BALTIMORE COUNTY, MARYLAND
DEPARTMENT OF PUBLIC WORKS AND TRANSPORTATION
DIVISION OF CONSTRUCTION CONTRACTS ADMINISTRATION
111 WEST CHESAPEAKE AVENUE
TOWSON, MARYLAND 21204

Contract Number 24084 SX0
Richlyn Manor Force Main
Perry Hall – District 11c5
Workday Number PROJ-1000060

ADDENDUM NO. 1

DATE: 5/14/2026

DEWATERING VALVE AND VAULT DETAIL

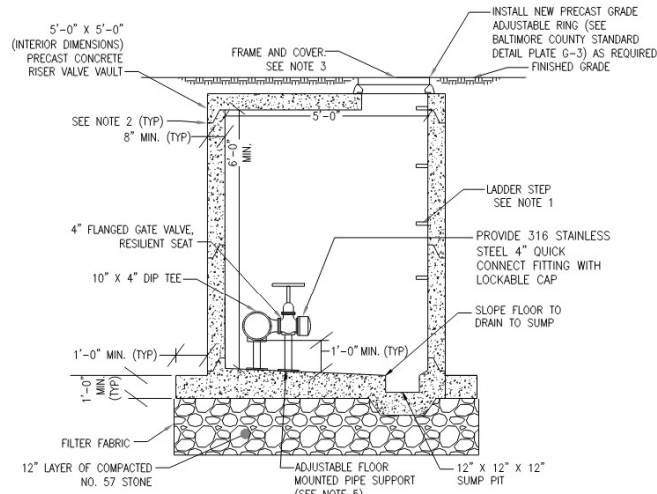
10. Drawing 2024-1152, C-15: Replace Detail 4 / C-15 – Dewatering Valve and Vault Detail with the following detail (see next page):

PLAN: STA. 13+50 TO STA. 17+50
SCALE: 1"=20'-0"

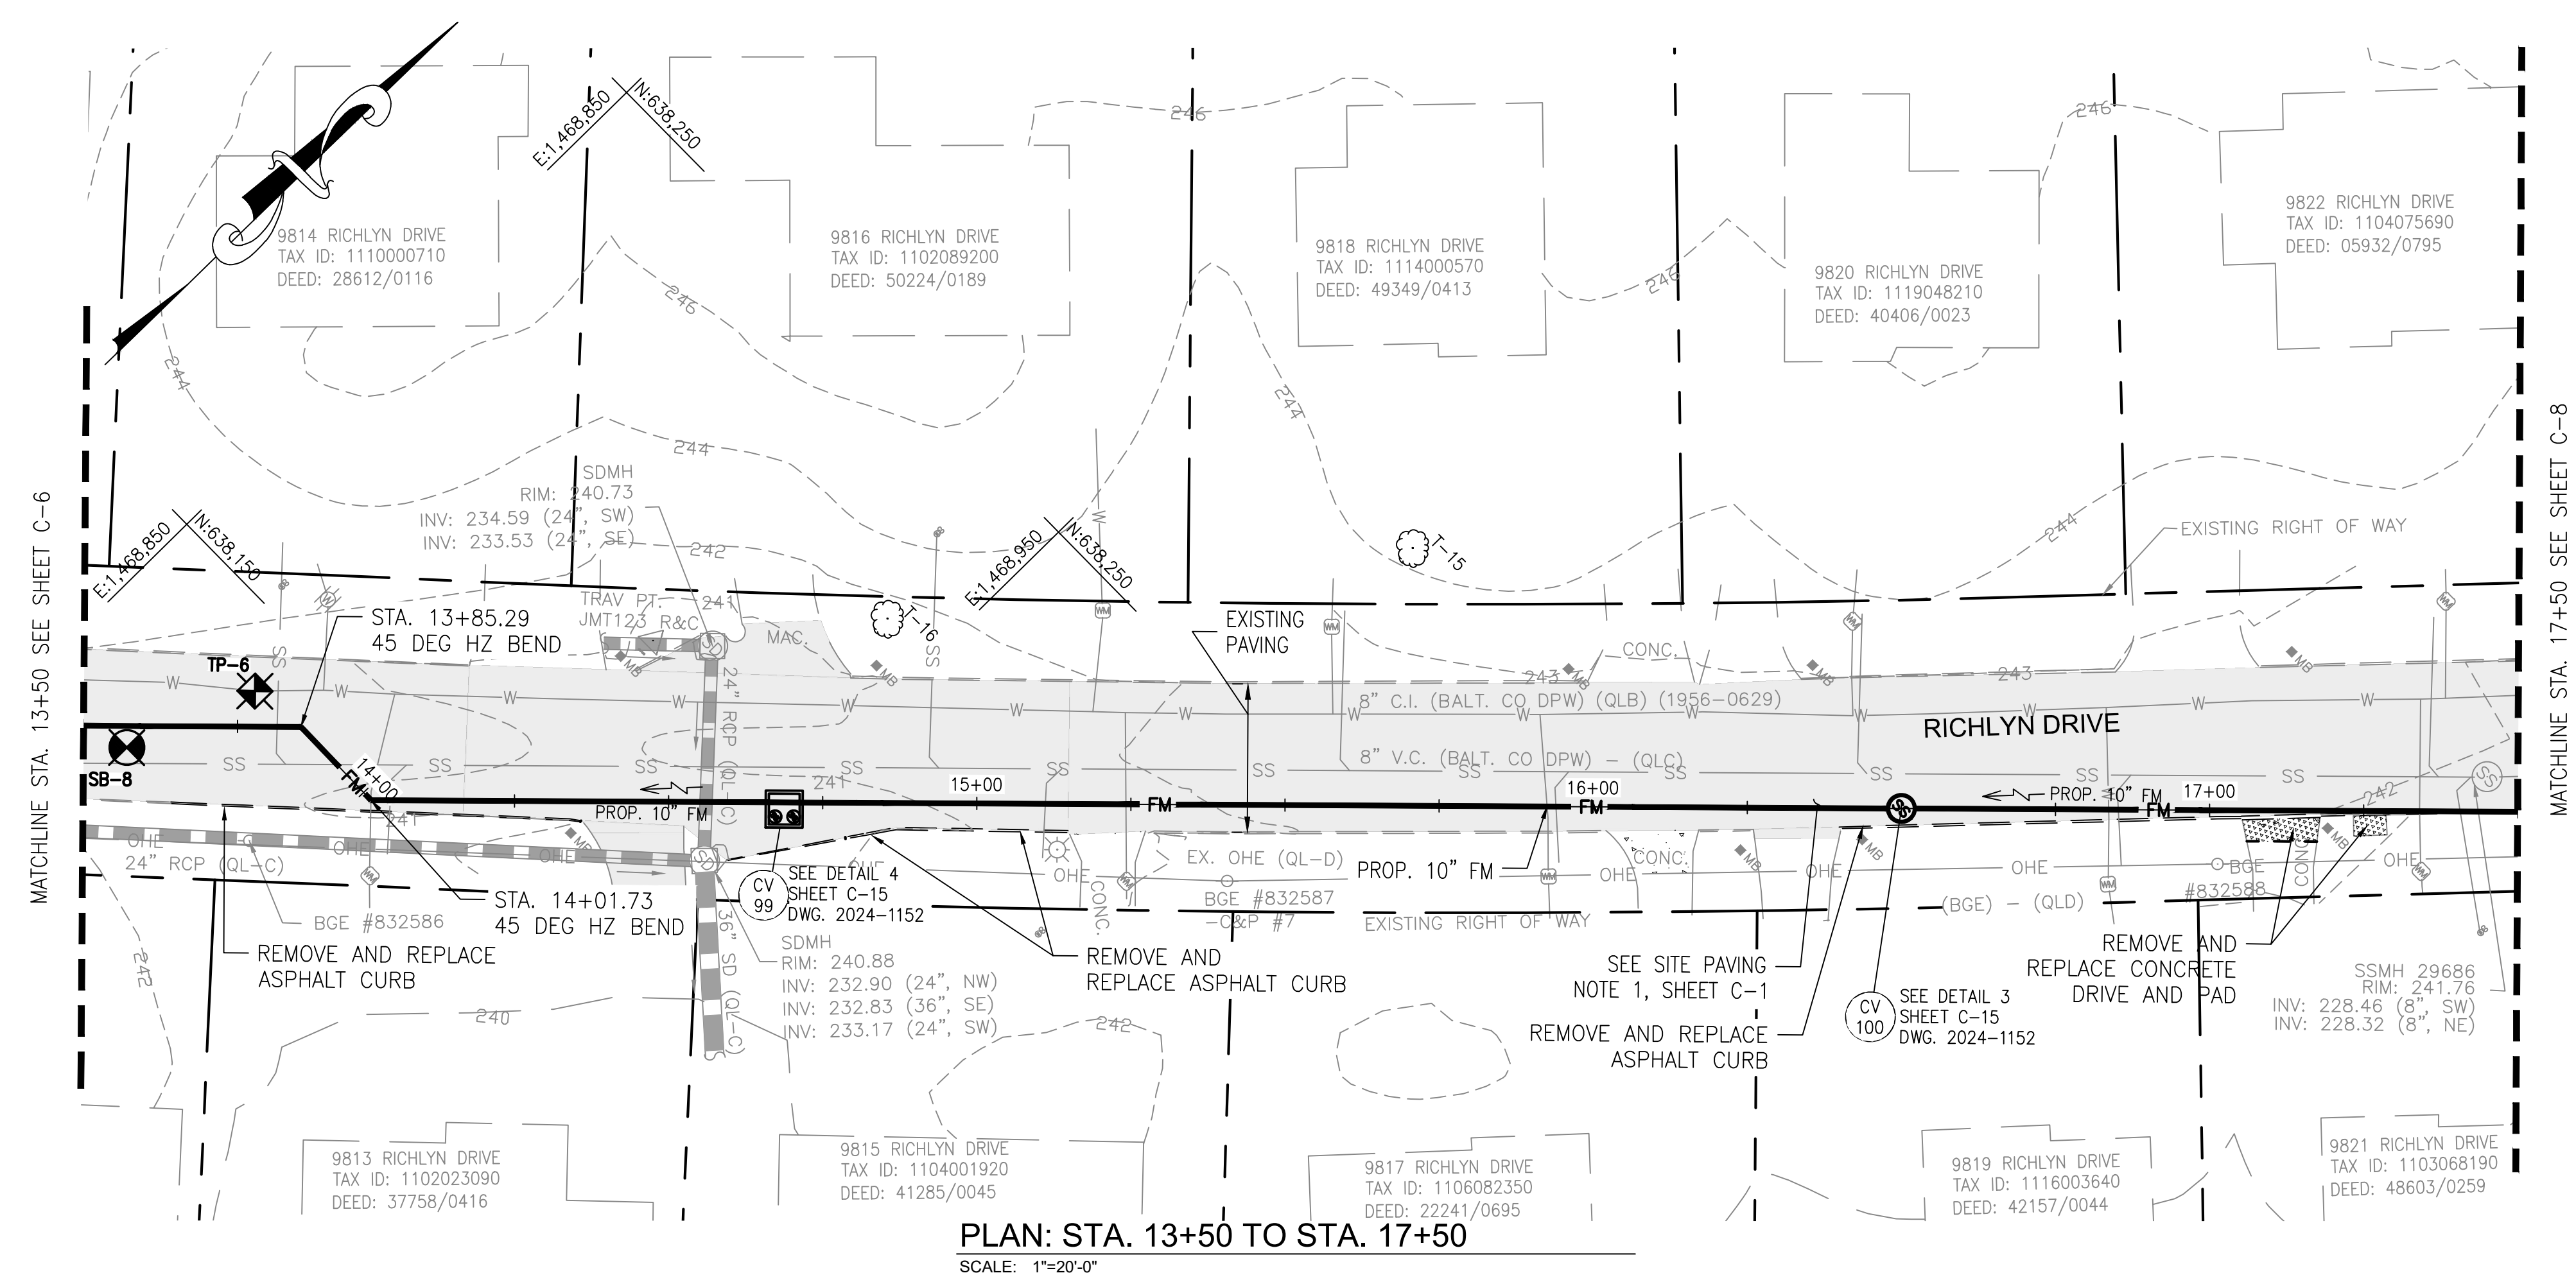
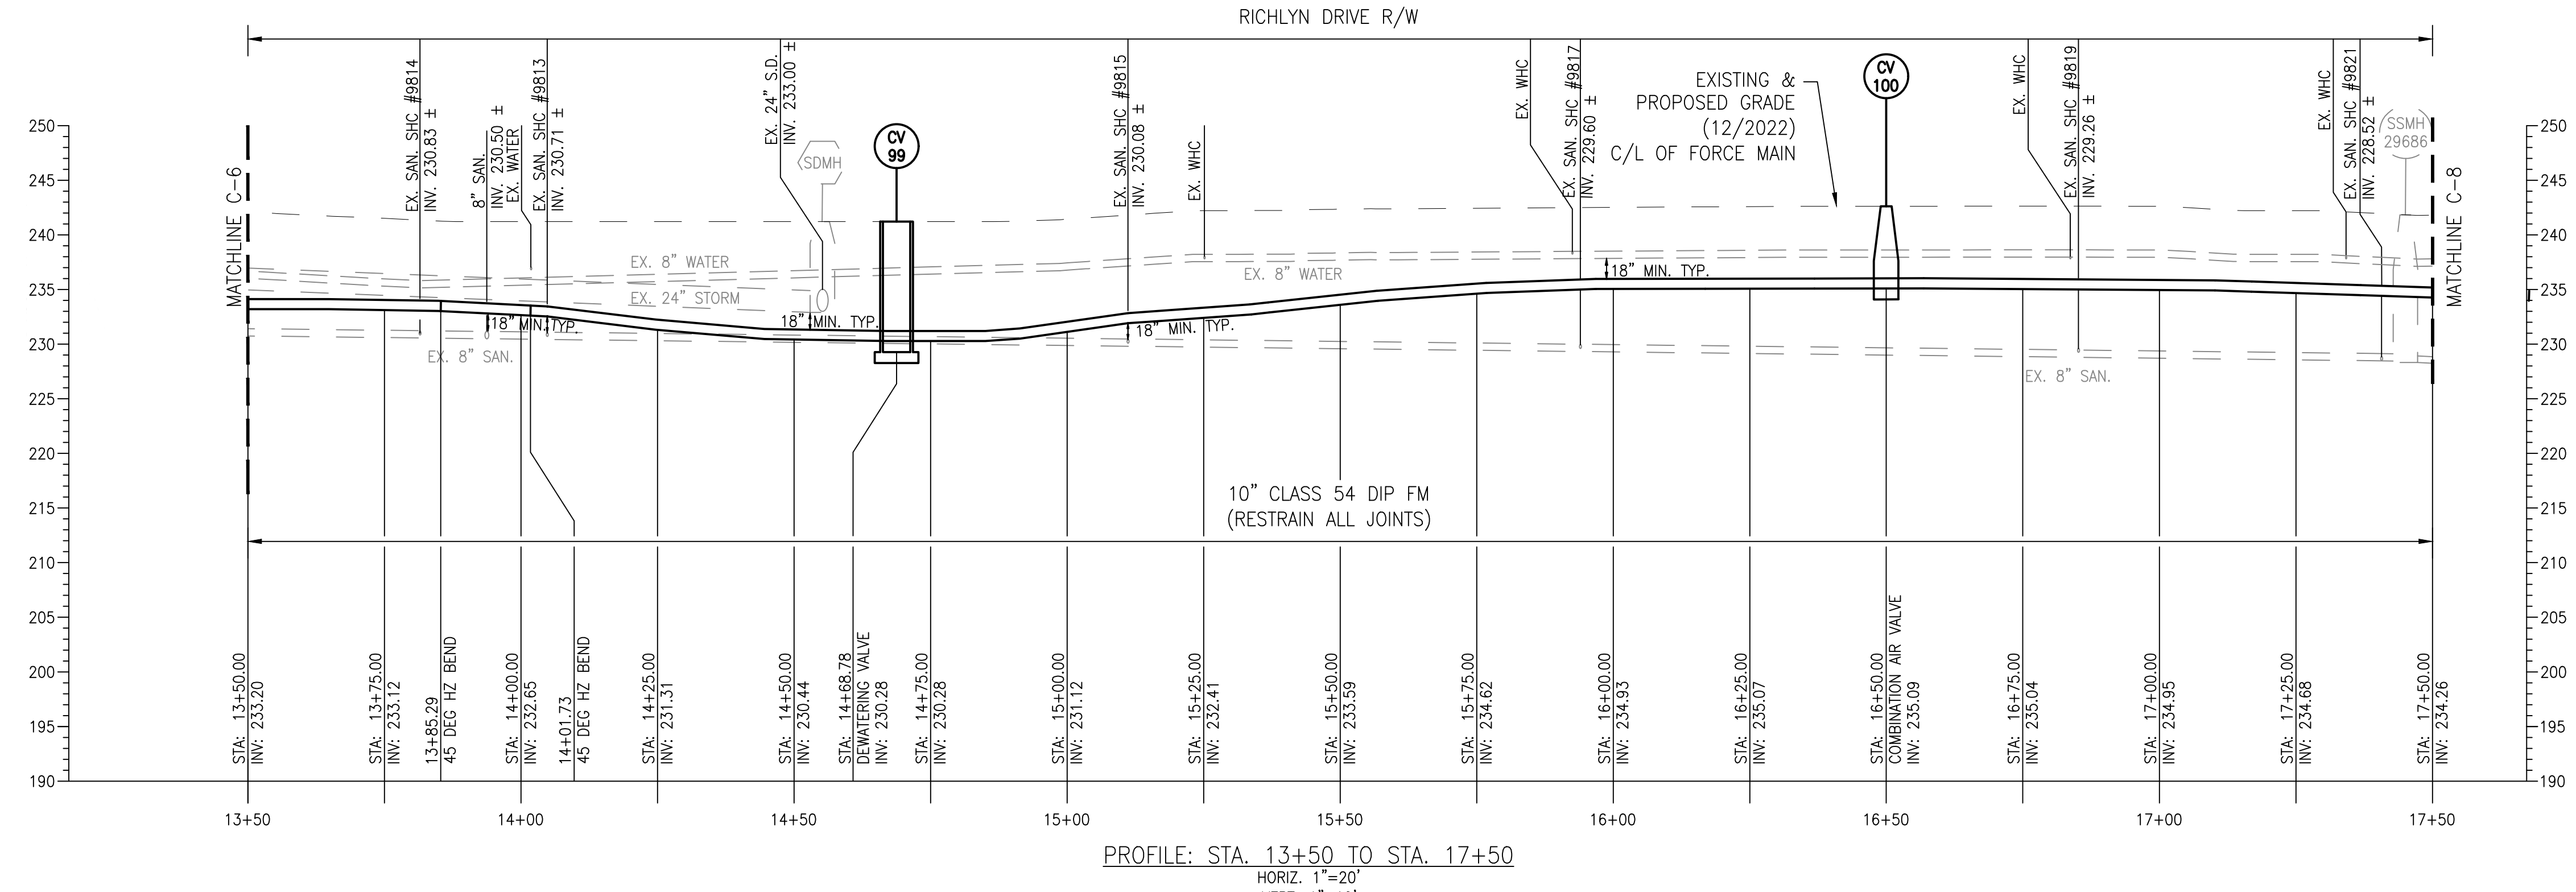
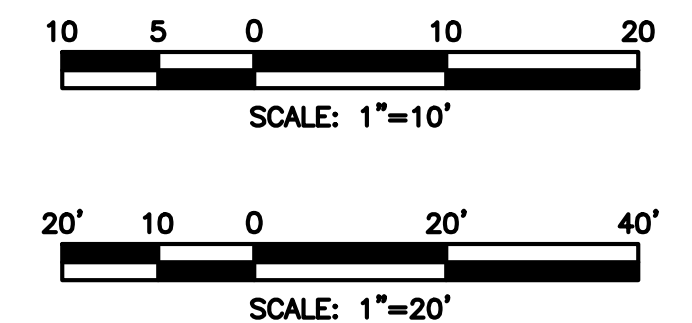
4. Drawing 2024-1144, C-7: Replace Sheet C-7 in its entirety with the attached revised Sheet C-7 which moves the dewatering vault from Station 14+82.85 to Station 14+68.78.

PLAN: STA. 17+50 TO STA. 21+50
SCALE: 1"=20'-0"

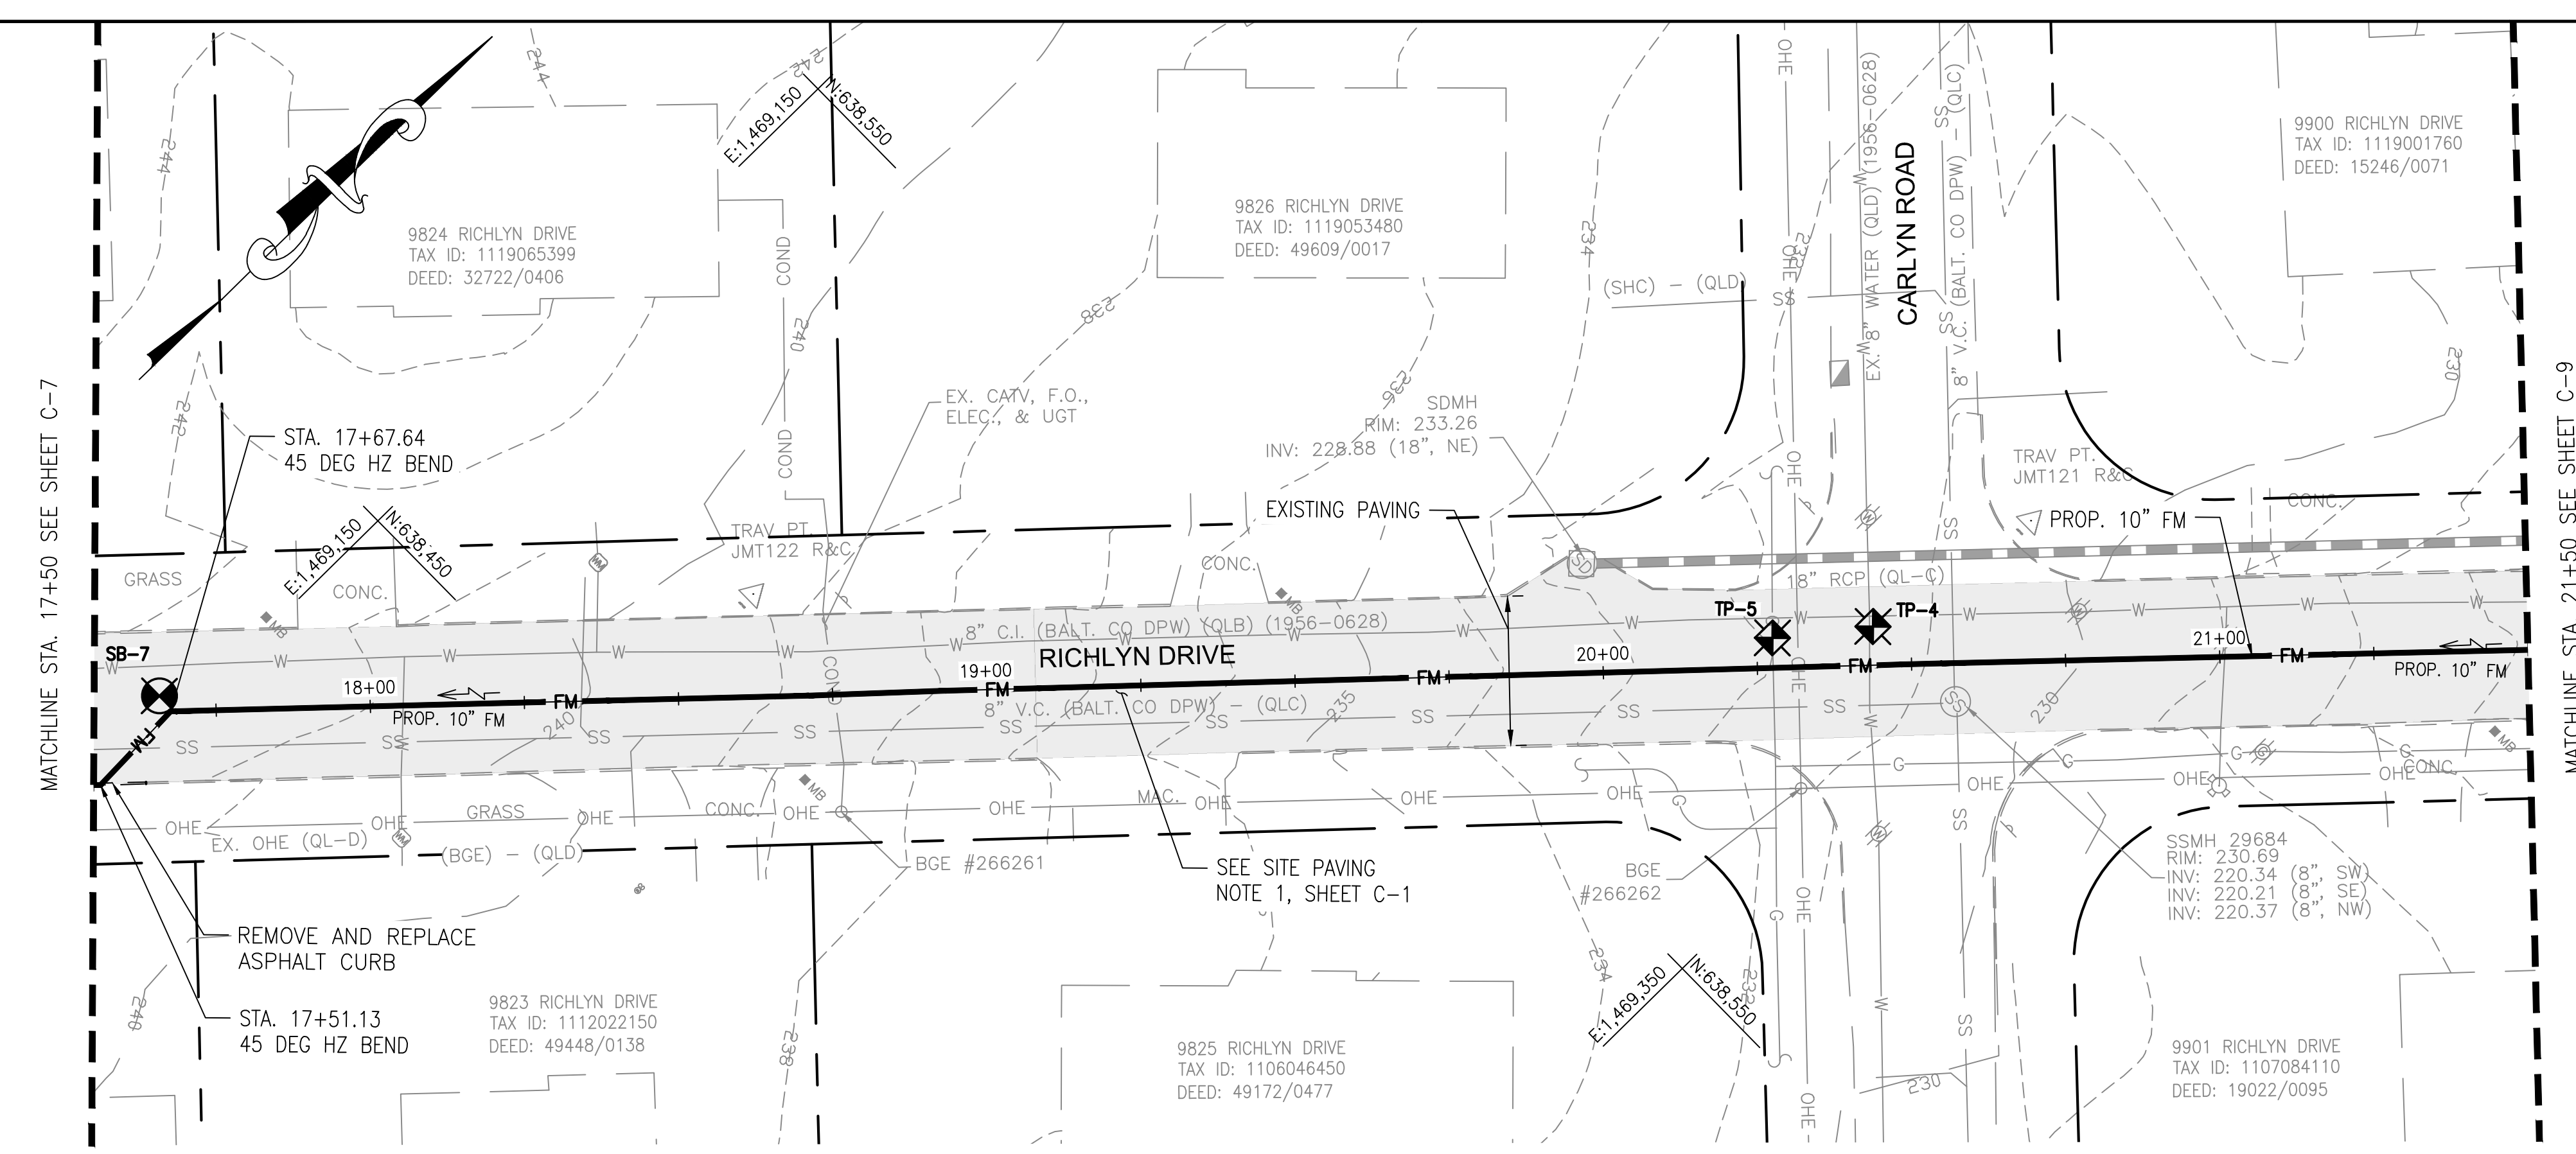
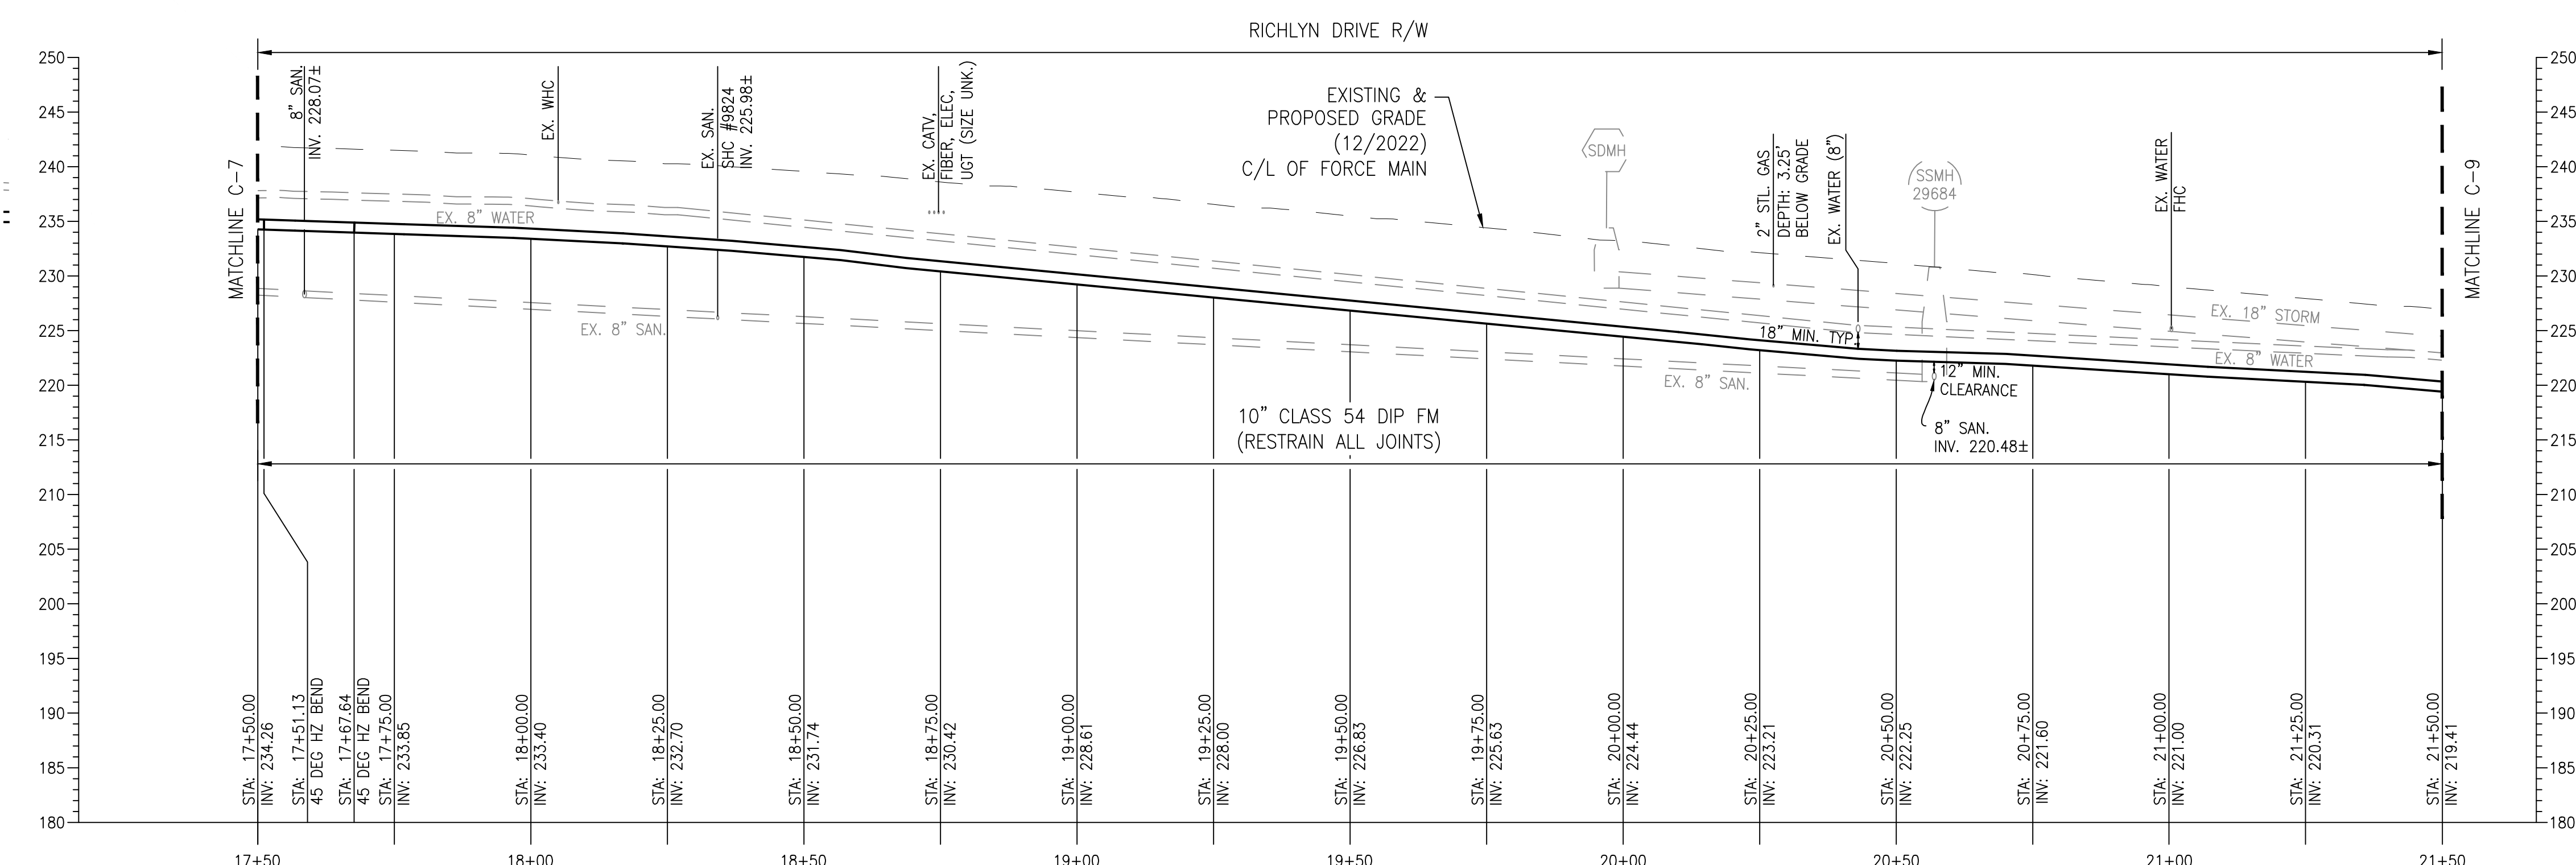
5. Drawing 2024-1145, C-8: Replace Sheet C-8 in its entirety with the attached revised Sheet C-8, which has been updated to show the EX. CATV, F.O., ELEC., & UGT buried conduits in the vicinity of STA 18+75.00 extended to 9824 Richlyn Drive.
